URGENT MEDICAL DEVICE CORRECTION

GEHC Ref# 30085

RE: T2100 Treadmill Uncontrolled Walking Belt Motion – Customer Owned Spare Parts

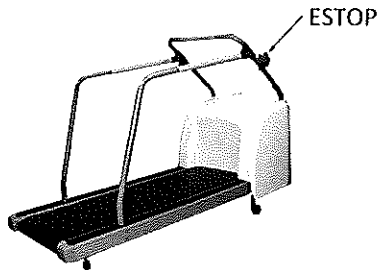
Safety Instructions 1) If your spare part drive has a FMI 30074 correction label attached (see below picture) or GE part number (2026182-006) ABB part number (3AXD50000032648, 3AXD50000032647 or FMH2A09TR-EN43HQ), the firmware on the drive was updated and your spare part is not affected. No further action is required except to **complete and return** the attached "Customer Response" form checking box #1 to indicate that you **do not** have affected spare part inventory and e-mail to DCAR.30085@ge.com.

Note: The spare part packaging is labeled with the GE part number and the Microflex drive is labeled with the ABB part number.
